**Bridgehaven Marina Maintenance Dredging: Project Proposal Clarification**

**For: Bridgehaven Community Club**  
151 North Beach Drive, Port Ludlow, WA 98365  
April 6, 2004

**Prepared by: Jim Johannessen, Licensed Engineering Geologist, MS**  
**Coastal Geologic Services Inc.**  
701 Wilson Ave., Bellingham, WA 98225, (360) 647-1845  
and **Amy Leitman, Marine Surveys & Assessments**

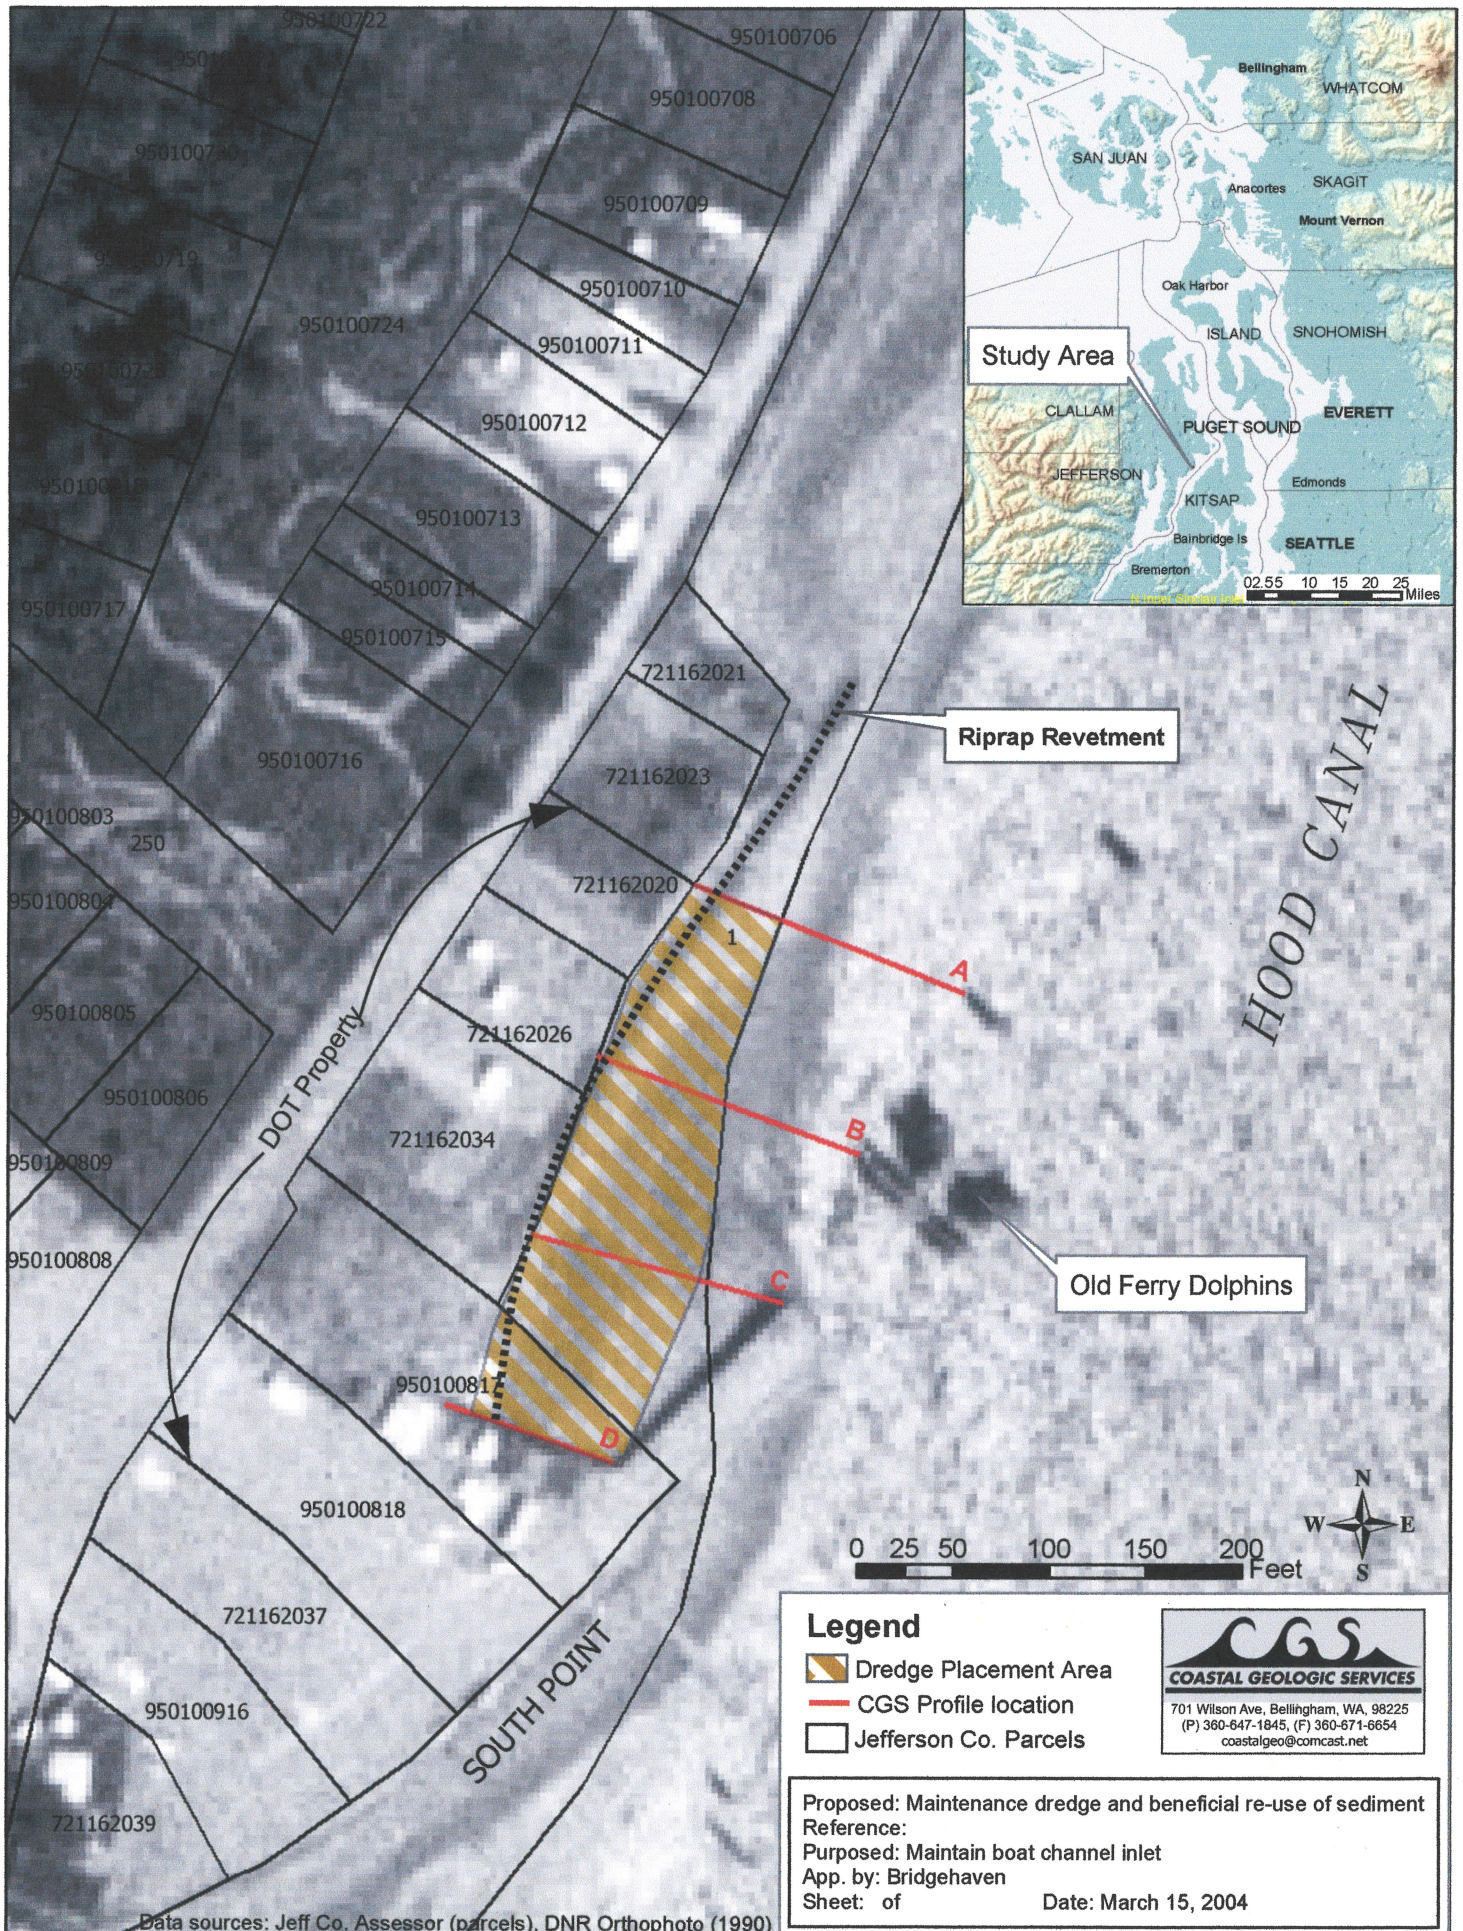
**Beach Nourishment Area:** The beach nourishment area is shown on the site plan prepared by Coastal Geologic Services Inc. dated March 15, 2004. Sandy dredge sediment would be placed atop the rock revetment that runs the length of the nourishment area, at varying elevations. Where the revetment is relatively high elevation, the nourishment sediment would go up to +16.0 ft MLLW. The elevation of the new crest of the nourishment sediment would vary between approximately +14.5 to +16.0 ft MLLW. The nourishment sediment would extend from the concrete bulkhead at the south end of the site northward for 300 ft to the north end of the WSDOT beach. The placement area would extend waterward to elevation +7.0 ft MLLW (shown on cross sections).

Nourishment sediment would be transported by closed (temporary) pipe from the hydraulic dredge to the nourishment area. The south end would be filled first, and work would continue northward. Sediment would be dewatered by pumping sediment waterward of a temporary 4-6 ft high ecology block wall that would be placed landward of the mean higher high water (MHHW) line. Sediment would be bulldozed south in steps (using multiple lifts) after dewatering, to rough, finish elevations. This process would be repeated several times moving the ecology block wall northward. The ecology blocks would be removed from the site completely after dewatering was complete, and rough grading would be completed.
